B-8 APPROVAL OF FINAL SCOPING REPORT

ACCEPTANCE OF THE SCOPING REPORT FOR THE PROPOSED DALMANUTHA WIND ENERGY FACILITY (WEF) AND ITS ASSOCIATED INFRASTRUCTURE NEAR BELFAST IN MPUMALANGA PROVINCE

Original 77 Turbine Layout (Pre-Optimised)

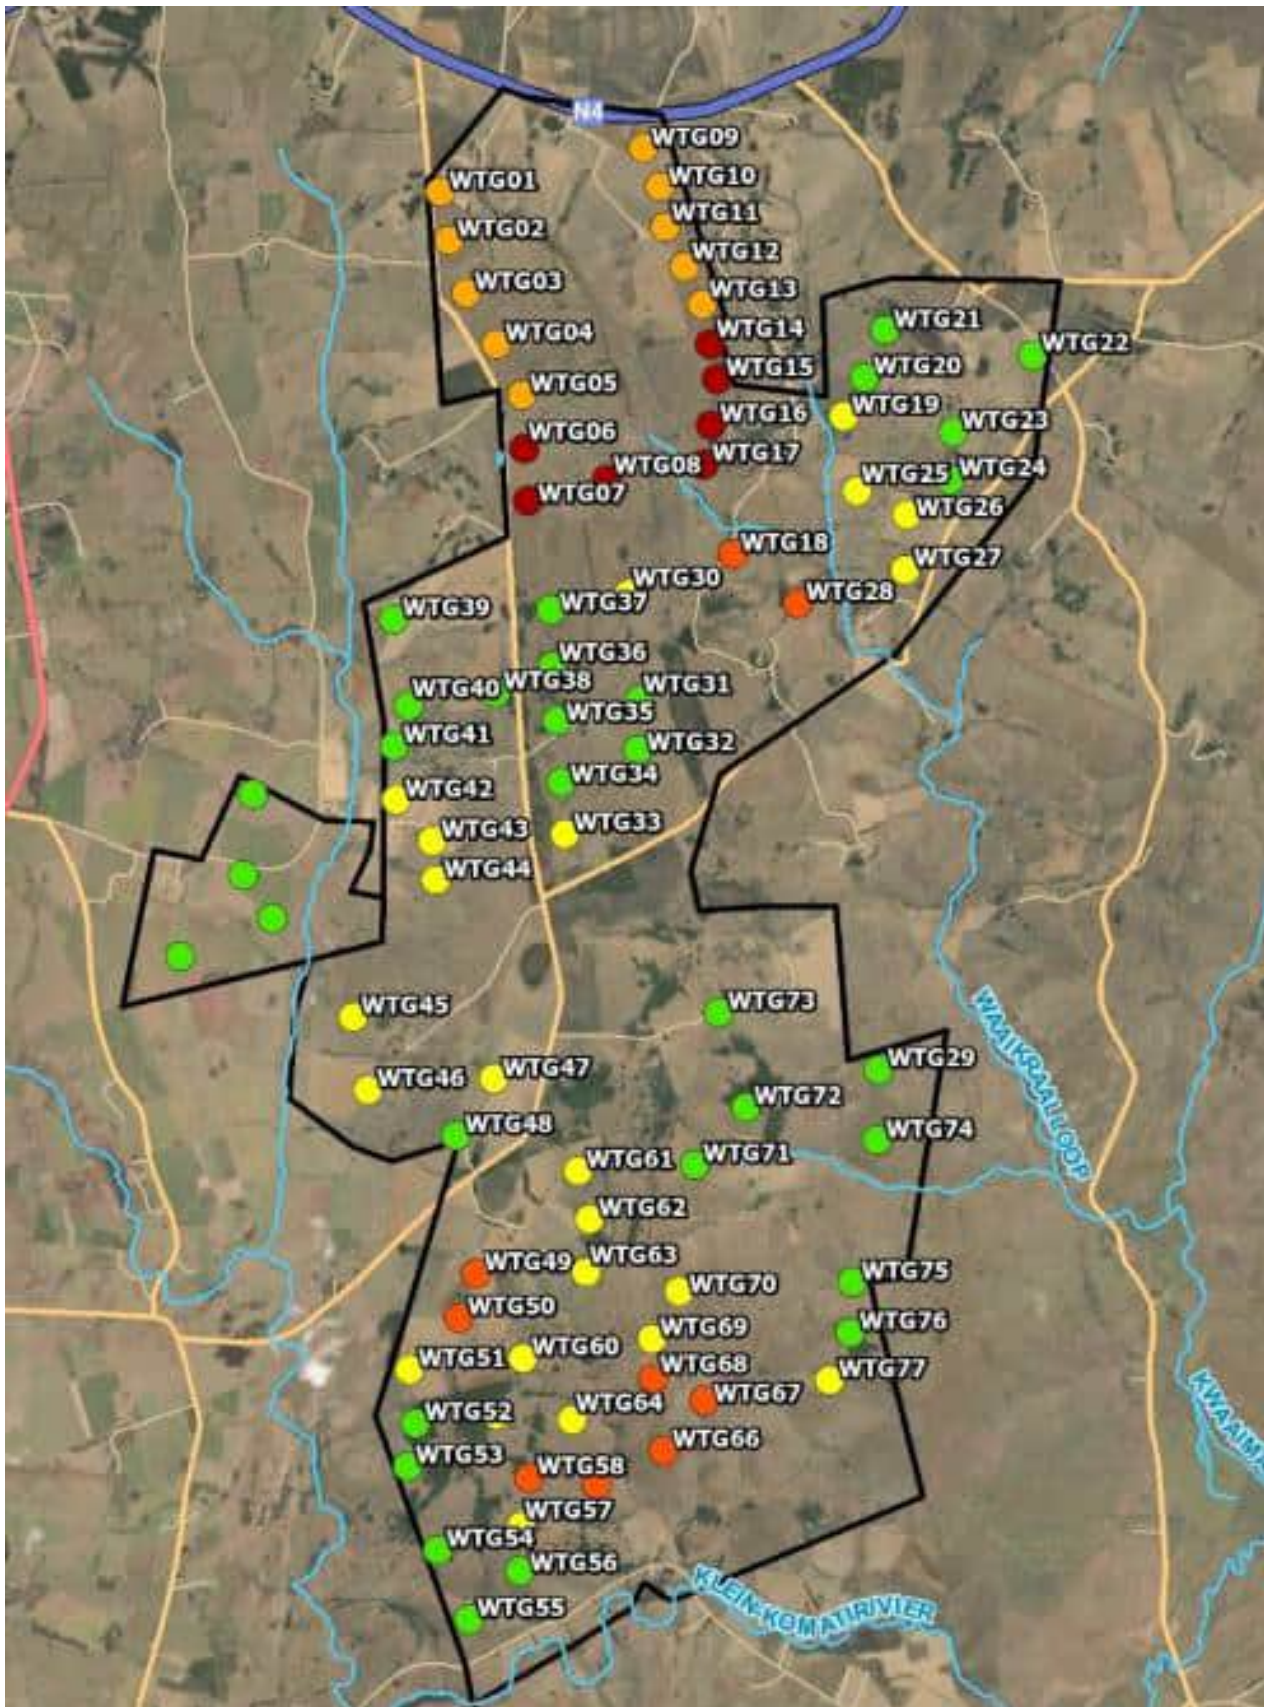
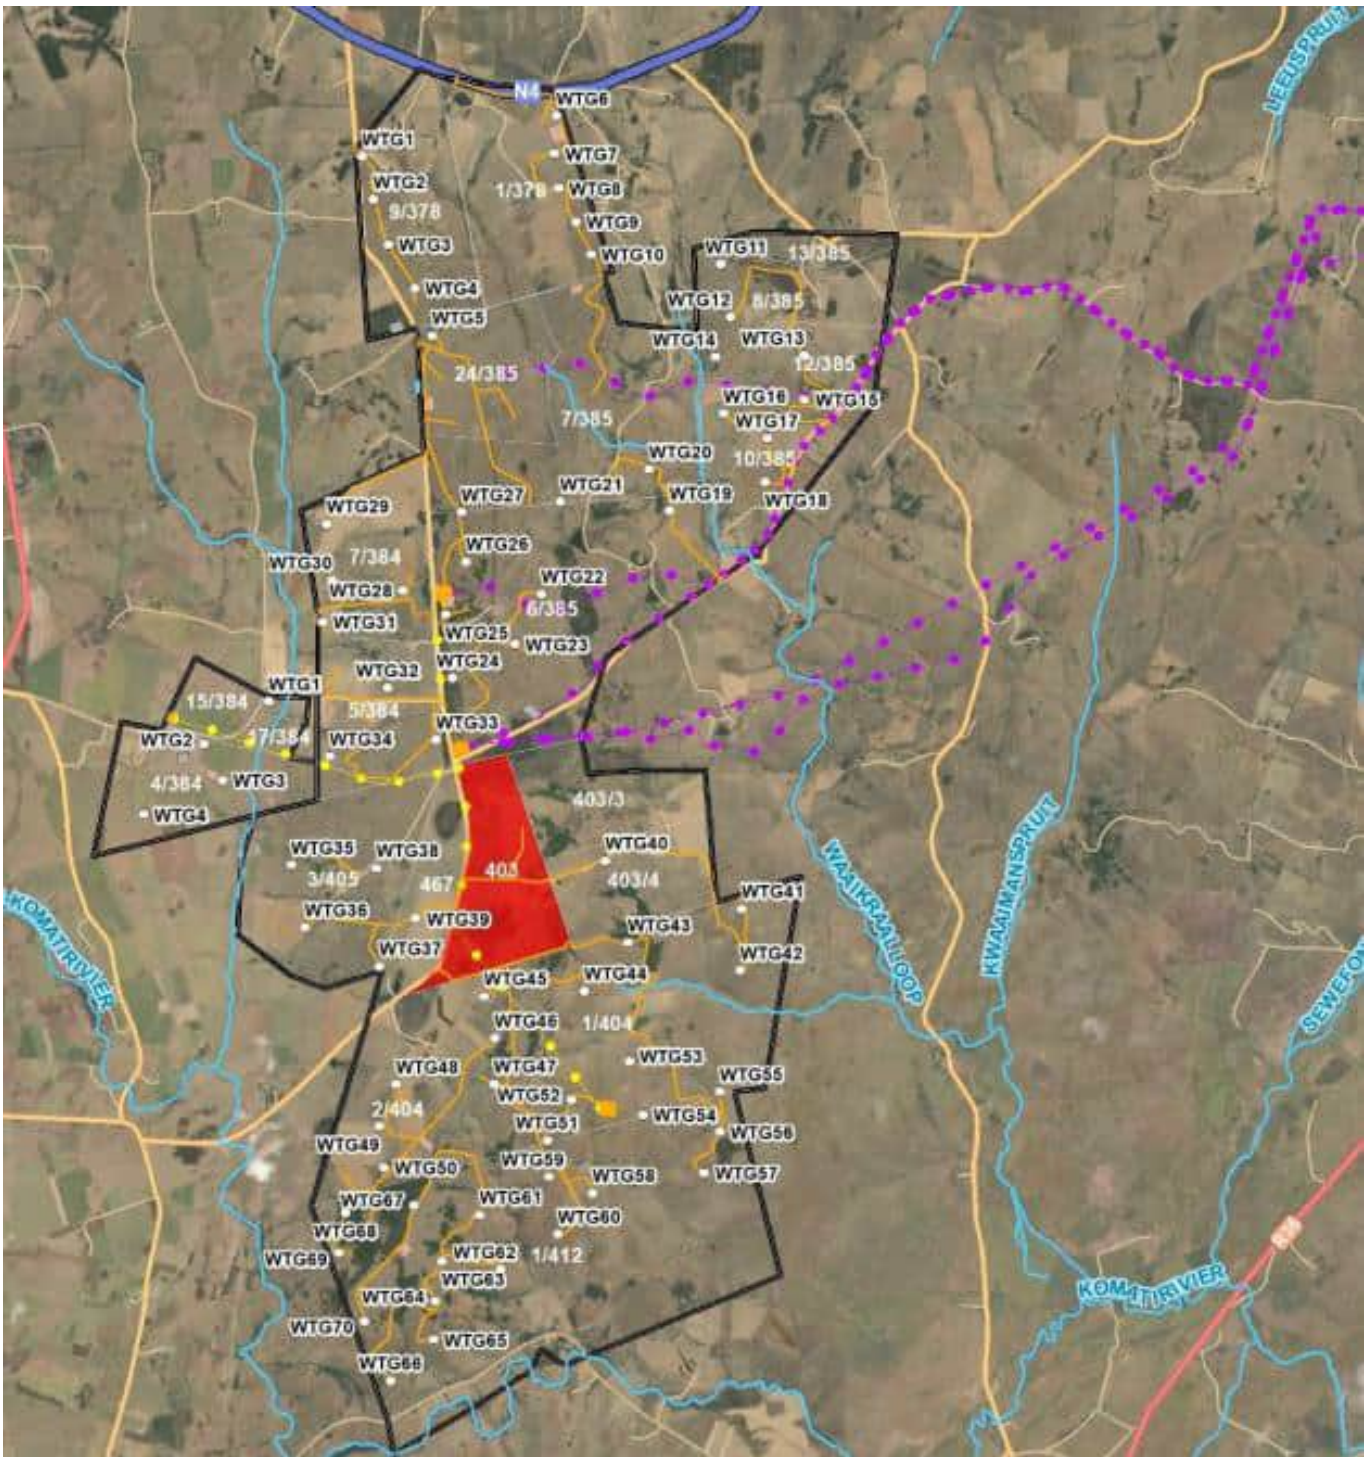
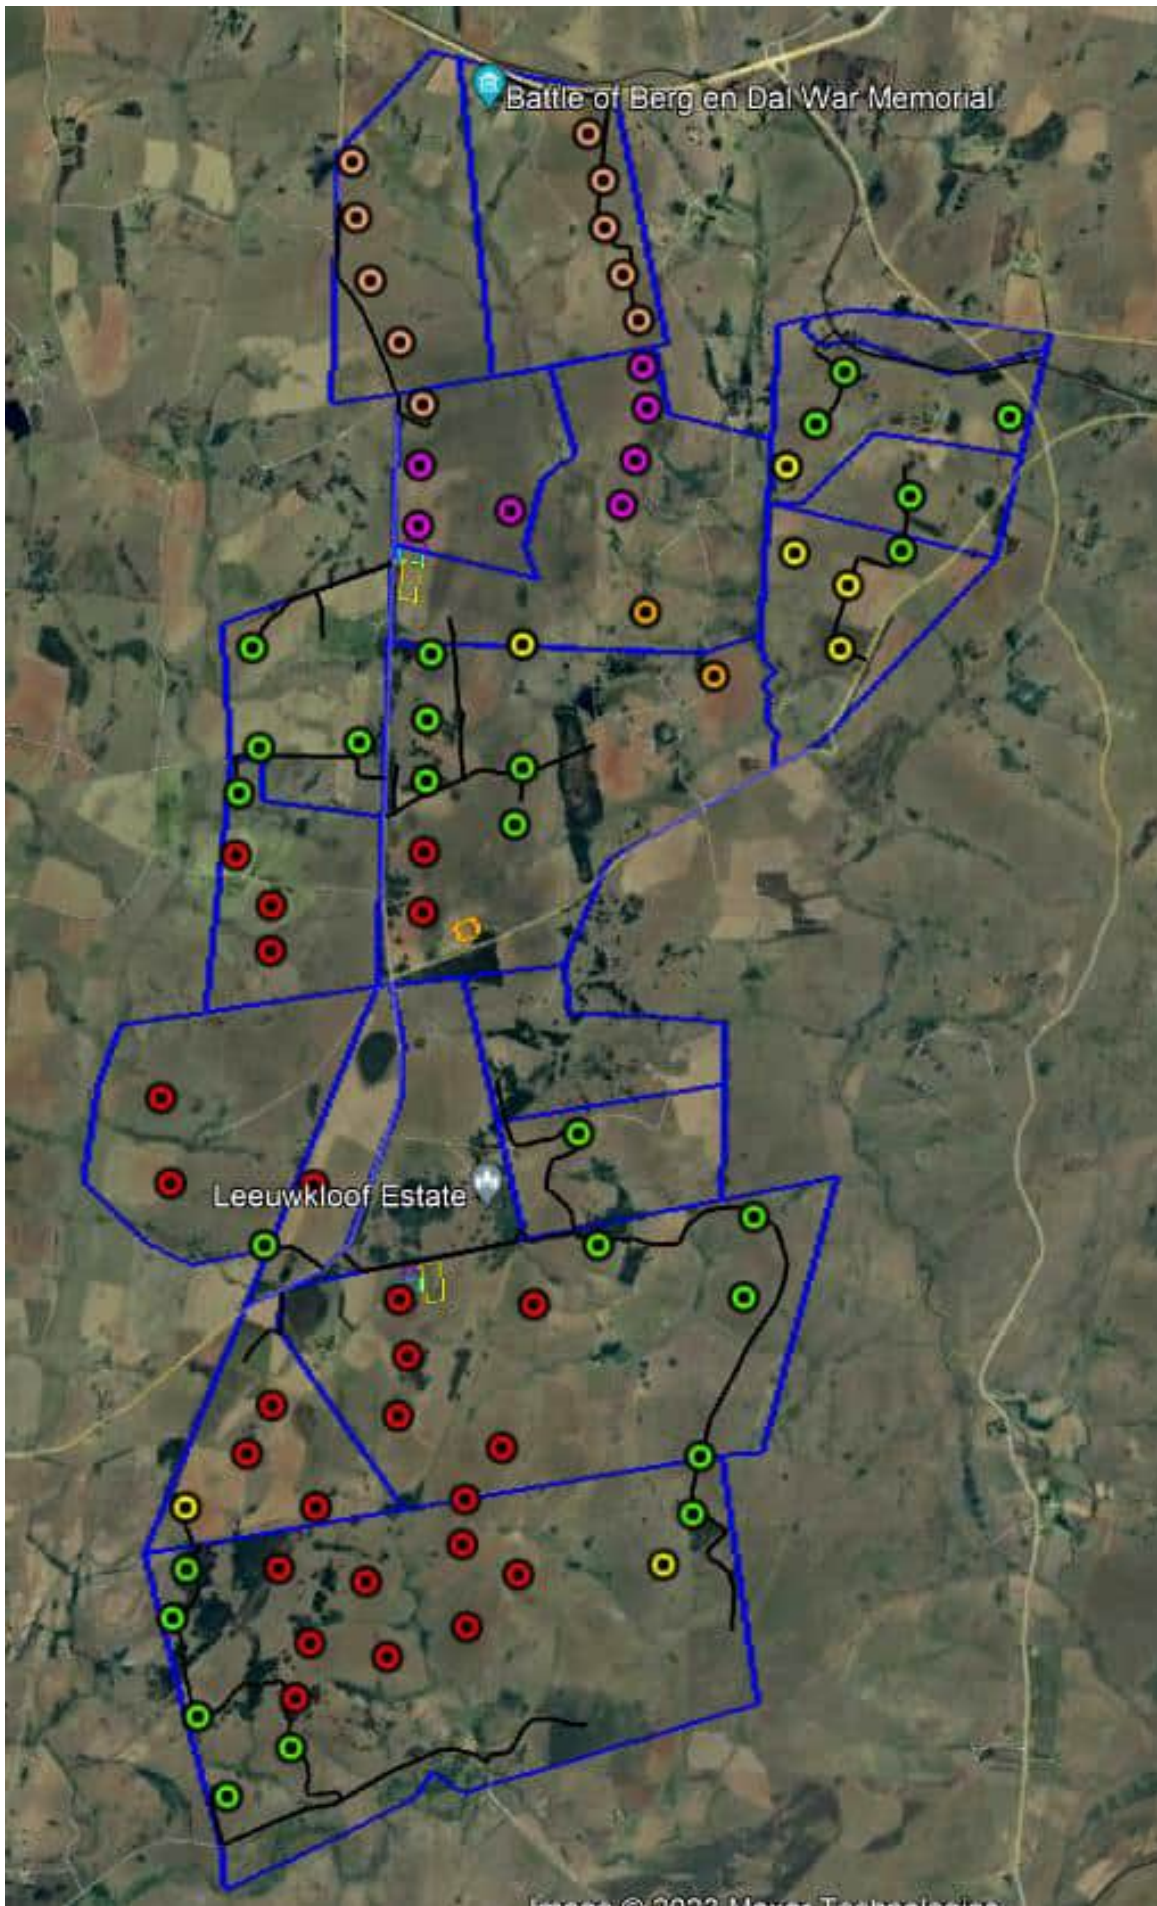
FK asked that if those turbines highlighted in red are of high risk, what mitigation is planned for them.

JS replied that the intention is to remove the high-risk turbines and not to mitigate the impacts associated with them.

Areas possibly available for Solar Technology

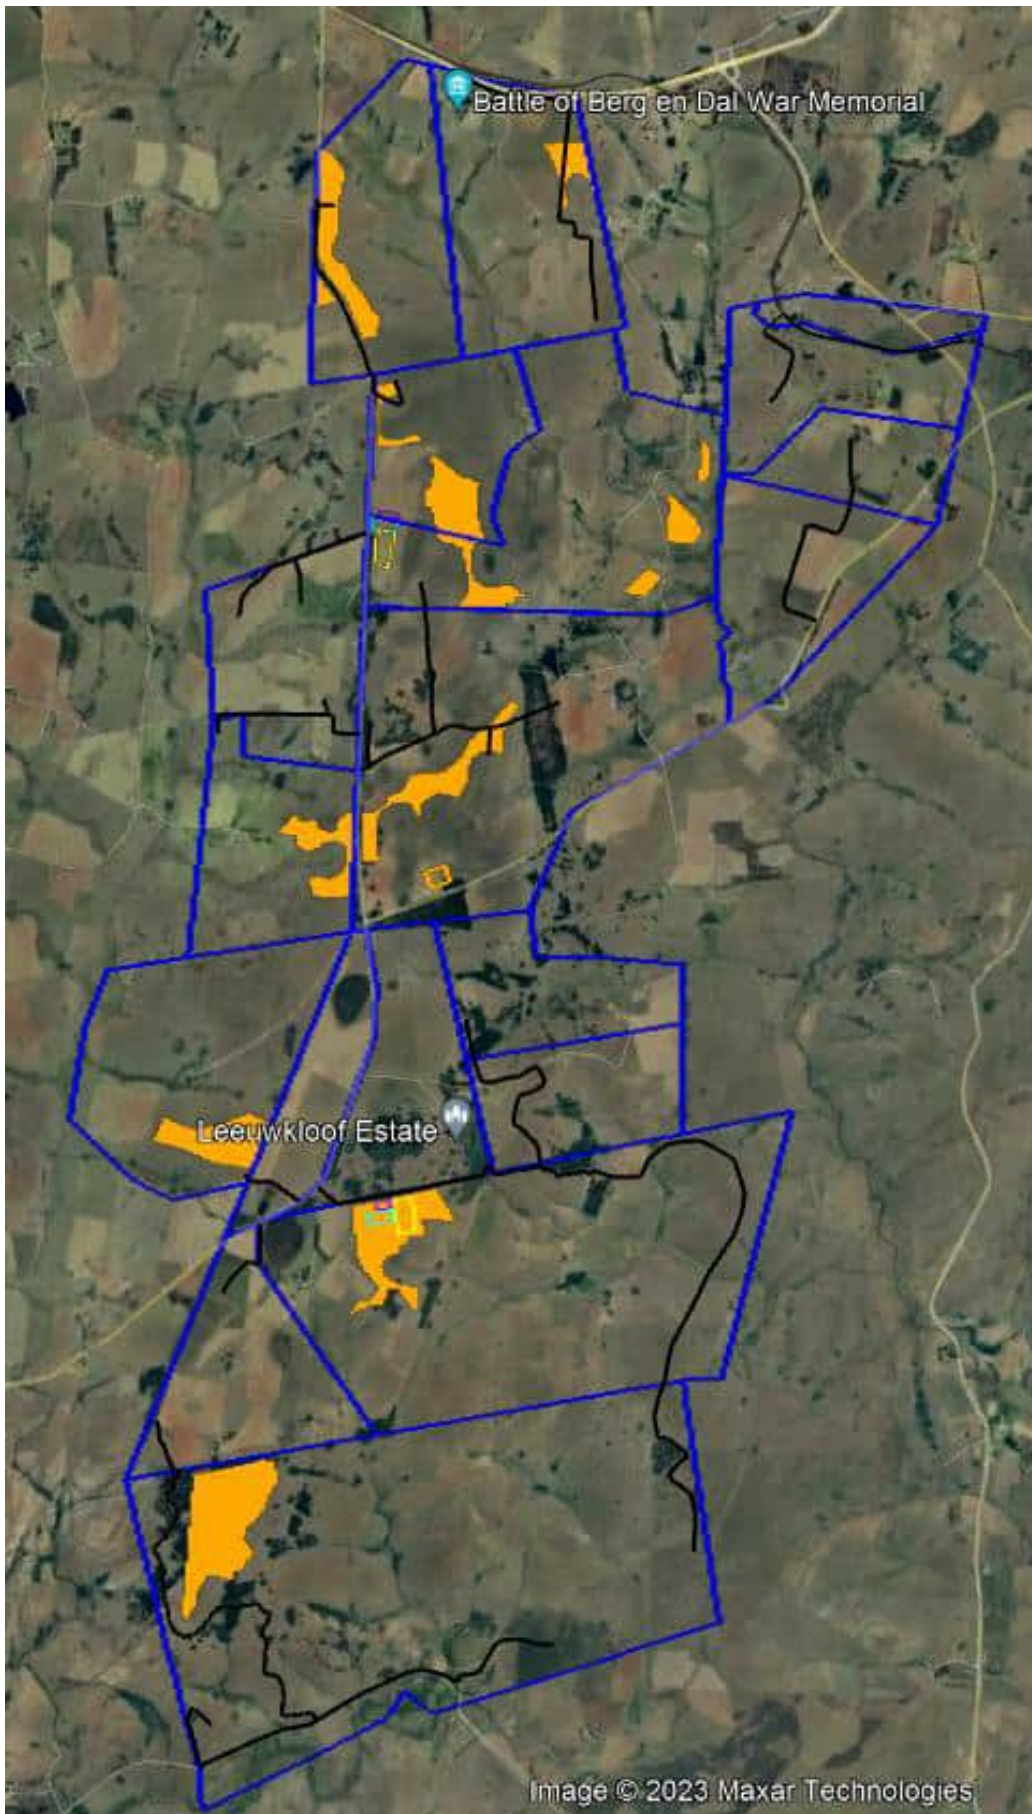
AS noted that there is a possibility of having a solar component added to the project in order to supplement the megawatt capacity and allow some of the high risk turbines to be removed. i.e., a hybrid facility.

Figure 2: 3D map of the entire Dalmanutha Wind Energy Facility showing the location of the wind turbines, MTPA species data, and the species data collected by the avifaunal specialist on behalf of the developer.

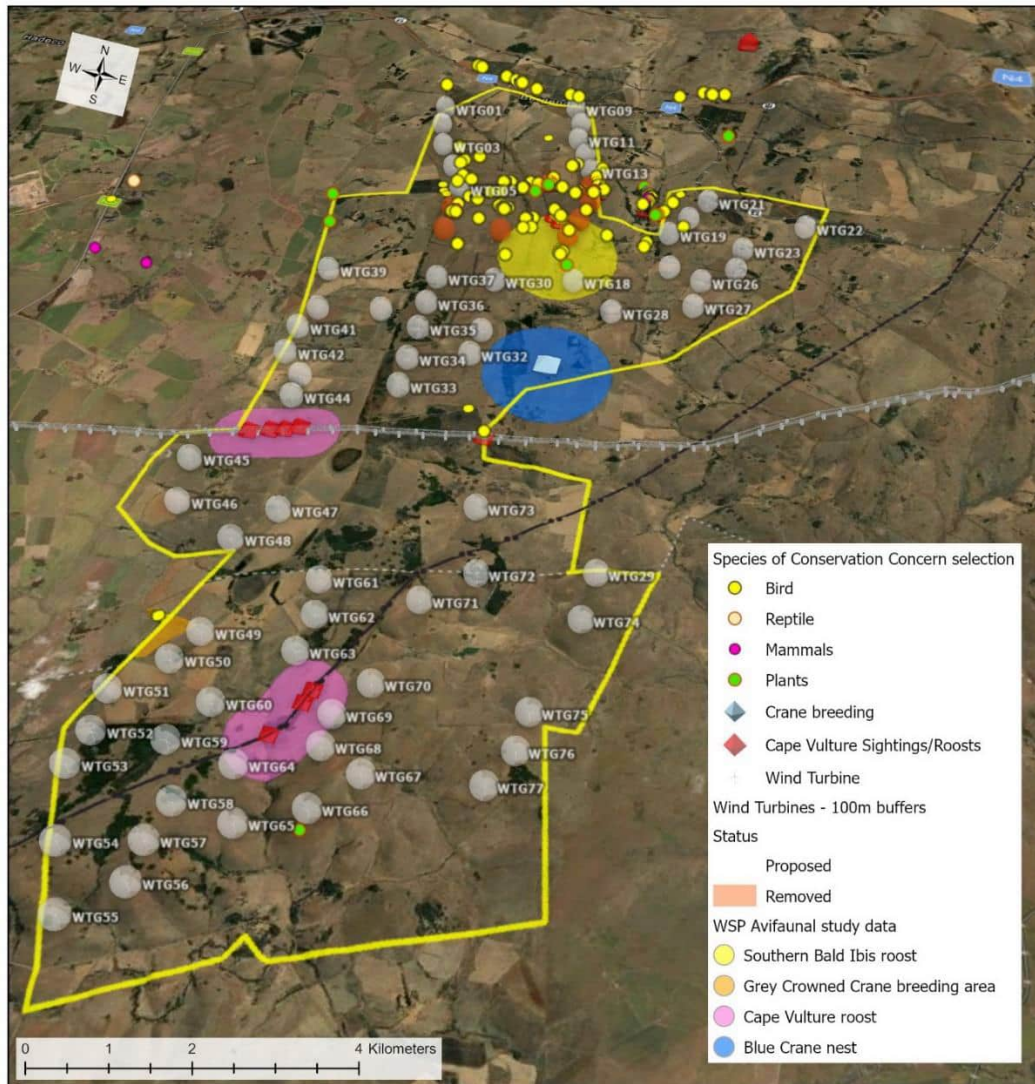
Many of the records in our database are based on collating observations from other scientists and research reports. This data is skewed towards areas which have been surveyed. In Figure 2, the map shows more records towards the north although we believe that if the same research effort was applied to the southern section, we would have a lot more observations for this area too as they are ecologically very similar.

<p>Many of the records in our database are based on collating observations from other scientists and research reports. This data is skewed towards areas which have been surveyed. In Figure 2, the map shows more records towards the north although we believe that if the same research effort was applied to the southern section, we would have a lot more observations for this area too as they are ecologically very similar.</p>	<p>EAP:</p> <p>This comment is acknowledged. The avifaunal findings in the EIA phase report will be based data collected from two years of bird monitoring which will adequately show the bird abundance and movement for both the northern and southern parts of the site.</p>
<p>The occurrence of the following specific bird species of concern</p> <p>The below sections highlights the occurrence of several bird species of conservation concern, where we feel that the proposed mitigation measures would be unable to protect these species from collisions.</p>	<p>EAP:</p> <p>This comment is acknowledged.</p>

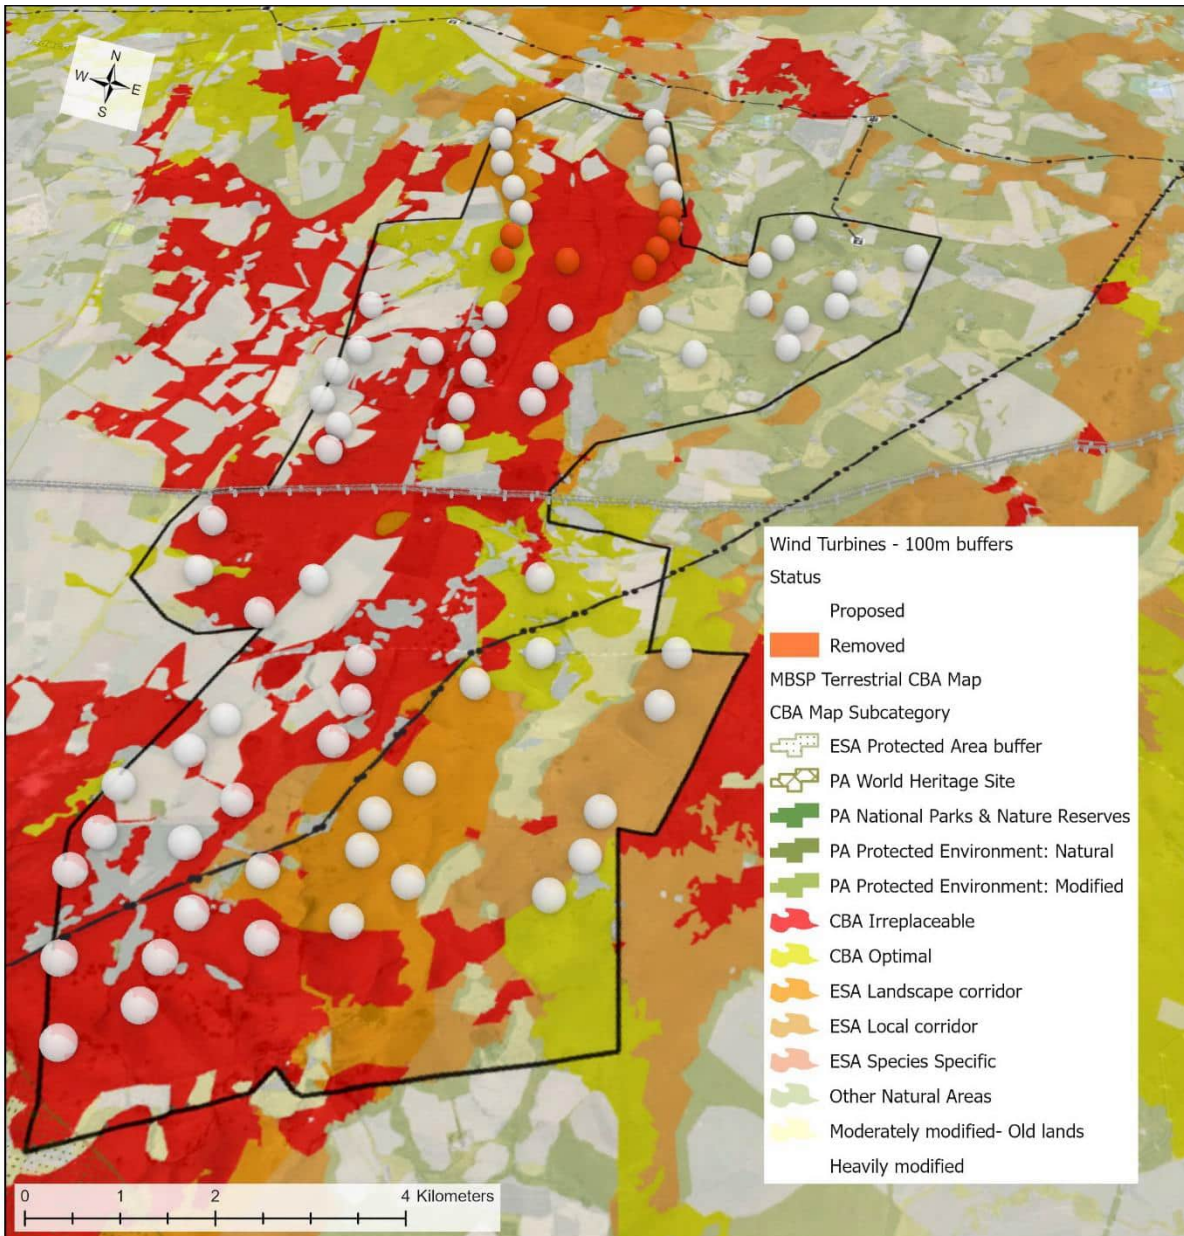
The draft scoping report acknowledges the significant occurrence of *Critical Biodiversity Areas (CBA) Irreplaceable* within the footprint area (Figure 4). The scoping report also acknowledges that the majority of the infrastructure is also placed within the National Protected Area Expansion Areas (2016) terrestrial priority focus areas. Both the desktop and specialist survey acknowledge the High Sensitivity of the terrestrial biodiversity. This sensitivity supports the concern we have around the difficulties of trying to mitigate impacts on provincial and national biodiversity priority areas. It is impossible to mitigate impacts on the *CBA Irreplaceable* areas.
